HISTORIC AND DESIGN REVIEW COMMISSION

HDRC CASE NO: 2021-030
ADDRESS: 547 DONALDSON AVE
LEGAL DESCRIPTION: NCB 6696 BLK 5 LOT 12
ZONING: R-6,H
CITY COUNCIL DIST.: 7
DISTRICT: Monticello Park Historic District
APPLICANT: FRANK GONZALEZ/KEYSTONE HOMES & PROPERTIES LLC
OWNER: ROSELYN DAJAO/KEYSTONE HOMES & PROPERTIES LLC
TYPE OF WORK: Fenestration modifications, window replacement
APPLICATION RECEIVED: January 15, 2021
60-DAY REVIEW: Not applicable due to City Council Emergency Orders
CASE MANAGER: Stephanie Phillips
REQUEST:

The applicant is requesting a Certificate of Appropriateness for approval to:

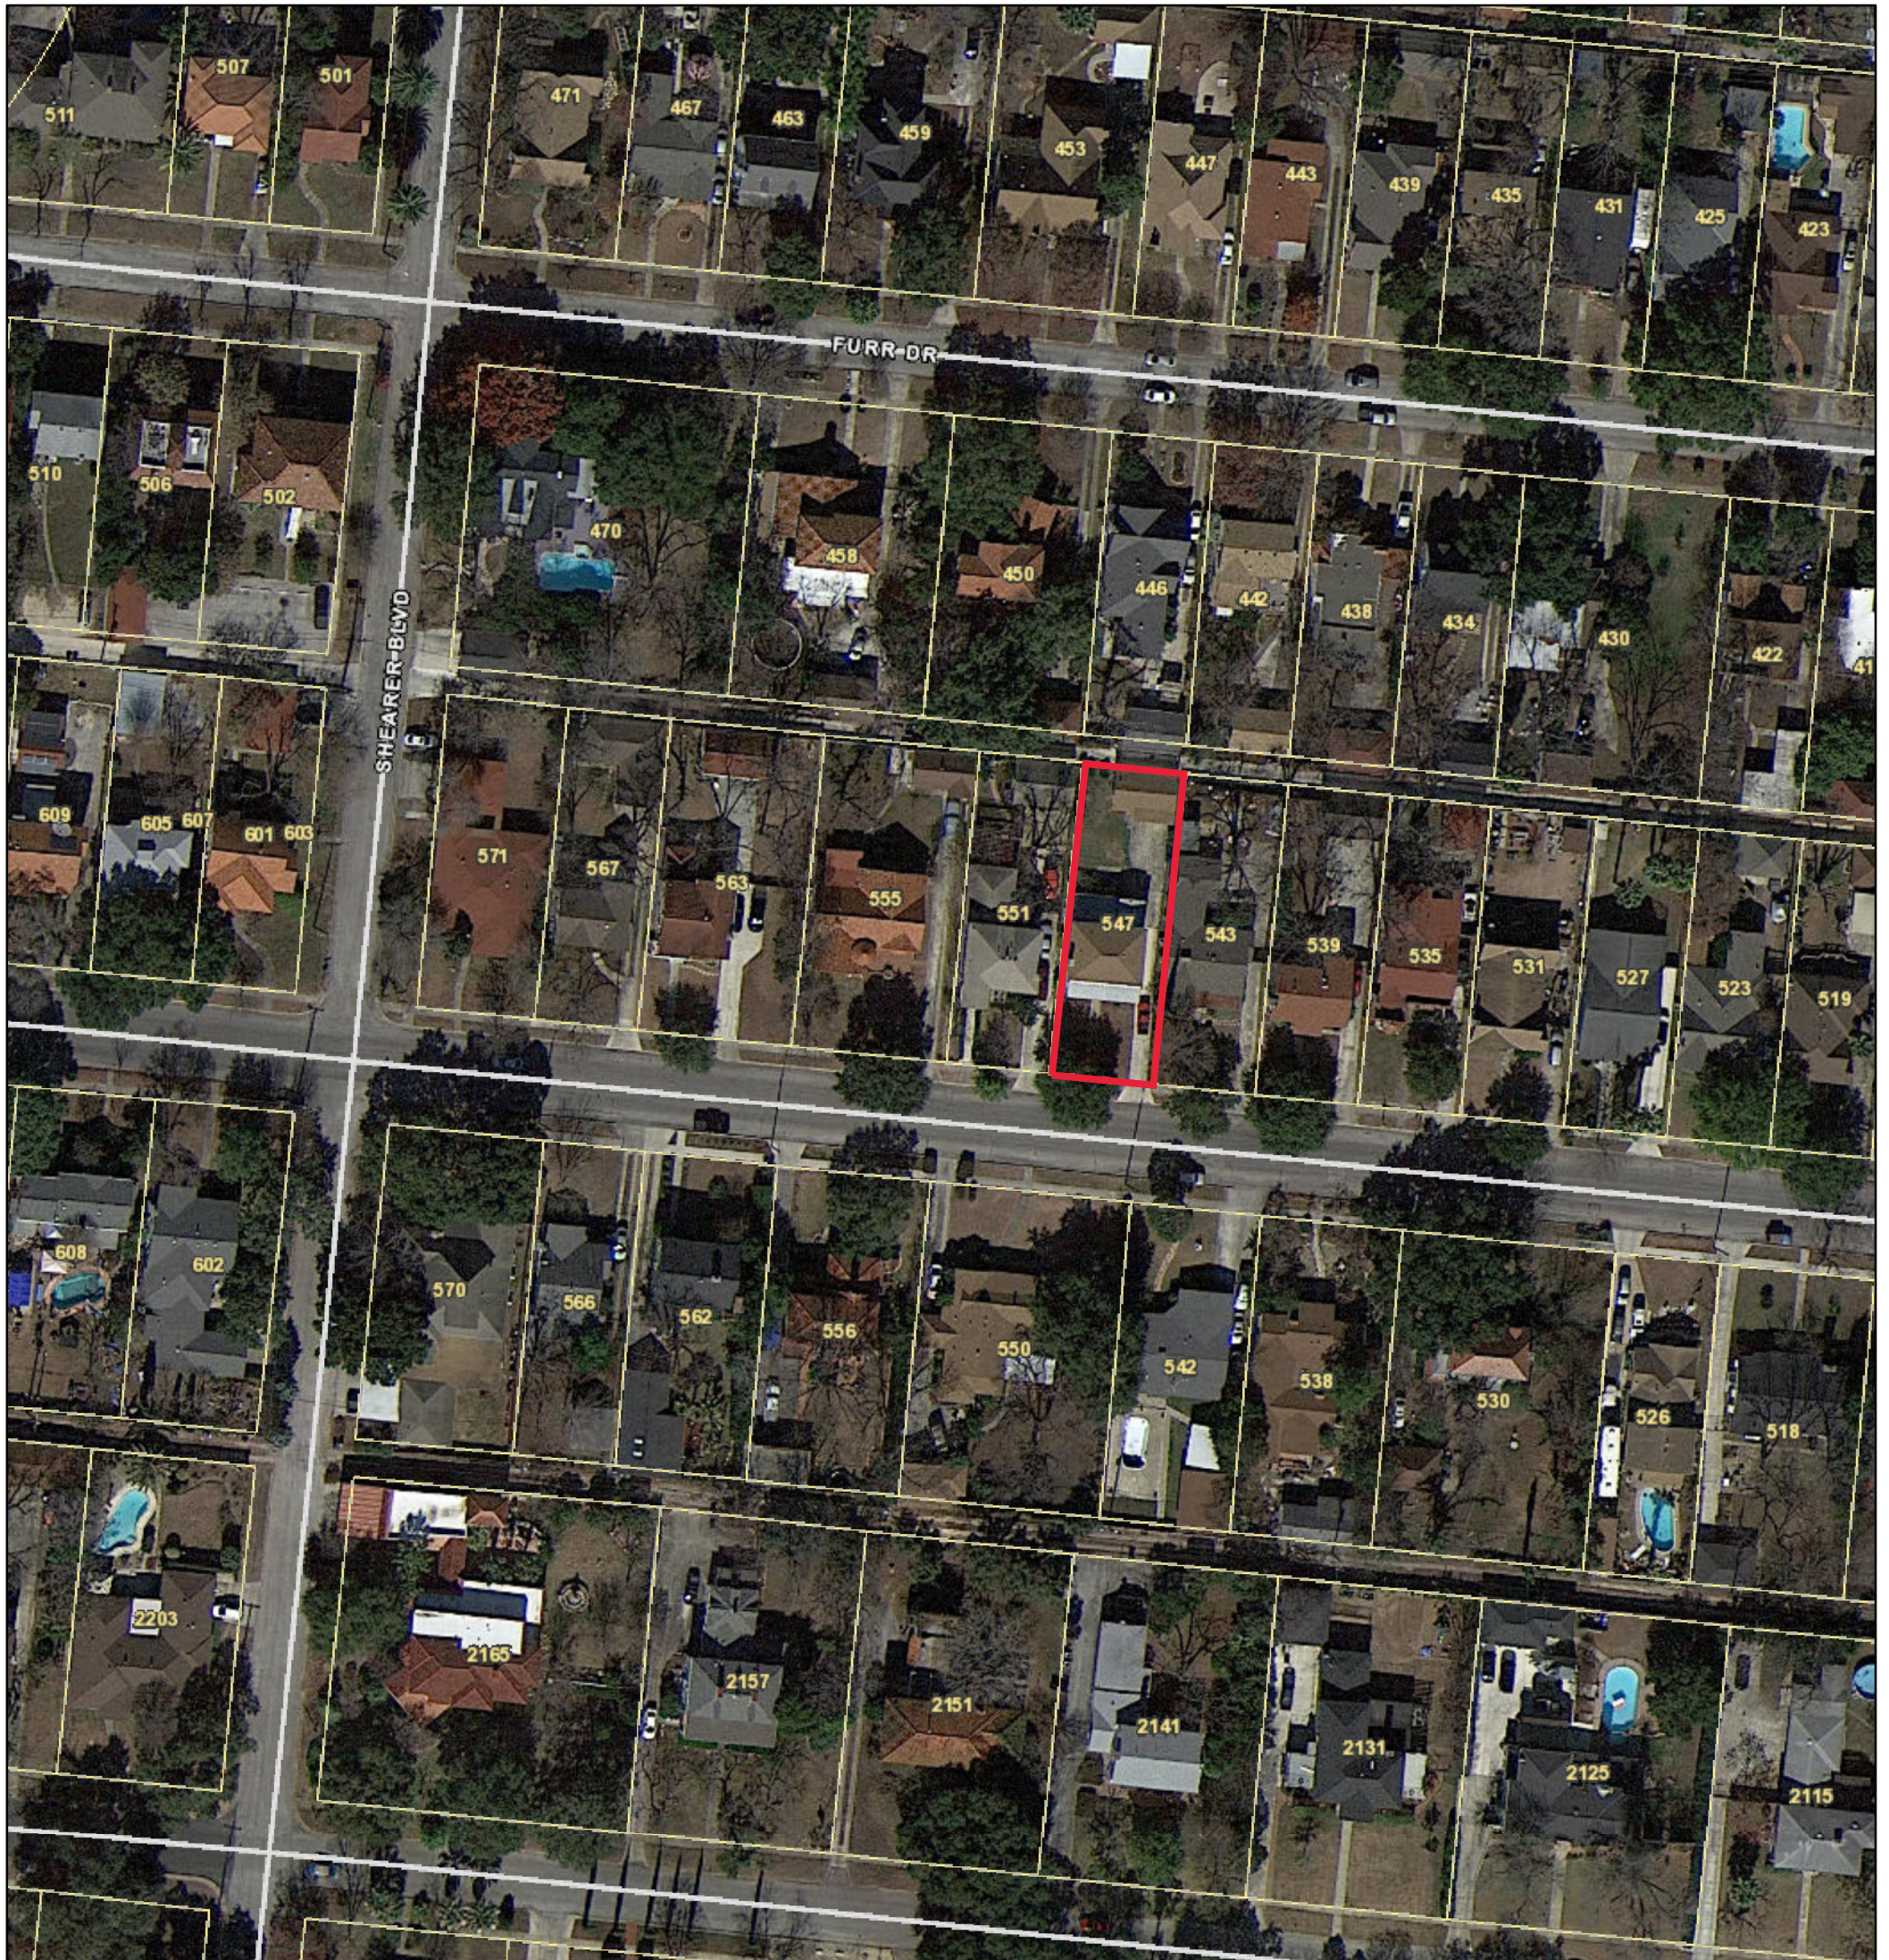
- c. **FENESTRATION MODIFICATIONS** - The applicant has requested to remove existing casement windows in the rear addition with new aluminum windows. The aluminum windows will be one over one to more closely match the windows in the primary structure, but will feature a silver finish and thinner rails and stiles. The applicant has noted that several of the windows exhibit evidence of improper repairs, painting of the exterior frames, and the deterioration or loss of functional elements. Based on these observations, staff finds that the replacement with an appropriate product is acceptable and will not result in the loss of character defining features

or high-quality historic material. However, staff finds that the requested replacement product is not consistent with the Guidelines or the stipulations listed in the recommendation.

- i. That the applicant submits final window specifications to staff for review and approval. Windows should be fully wood or clad wood and feature an inset of two (2) inches within facades and should feature profiles that are found historically within the immediate vicinity. White color is not allowed, and color selection should be presented to staff. Meeting rails must be no taller than 1.25" and stiles no wider than 2.25". There should be a minimum of two inches in depth between the front face of the window trim and the front face of the top window sash. This must be accomplished by recessing the window sufficiently within the opening or with the installation of additional window trim to add thickness. Window trim must feature traditional dimensions and an architecturally appropriate sill detail. Window track components must be painted to match the window trim or be concealed by a wood window screen set within the opening.

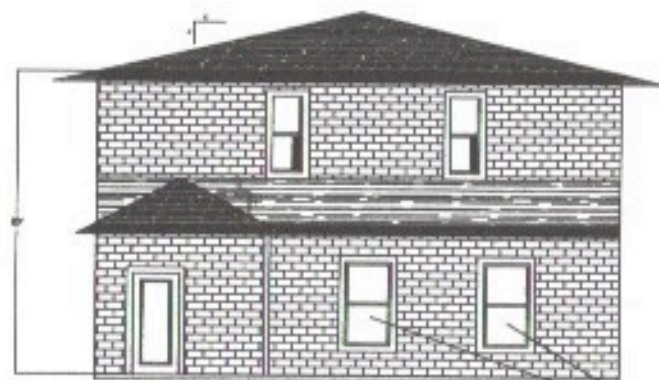
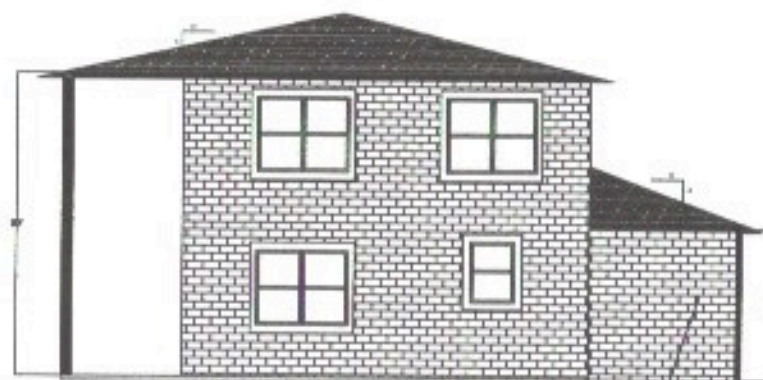
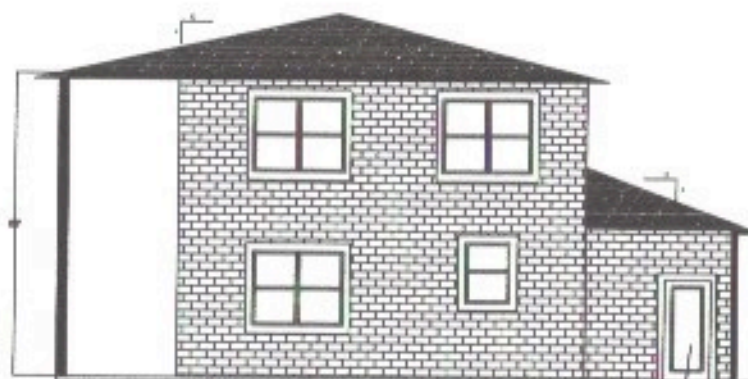
- b. **WINDOW REMOVAL** – The applicant has proposed to remove an existing casement window on the existing left elevation of the rear addition and enclose with brick to match existing. The addition is not visible from the public right-of-way. Staff generally finds the request appropriate with the stipulations listed in the recommendation.

- d. NEW DOOR - The applicant has proposed to install a new pedestrian door on the right side of the rear addition. The current location is a blank wall. Staff finds the request appropriate.

Staff recommends approval of the request items based on findings a through d with the following stipulations:

- ii. That the casement windows to be removed or replaced be salvaged and stored on site for future use or donated. A salvage or donation plan must be submitted to staff prior to the issuance of Certificate of Appropriateness.
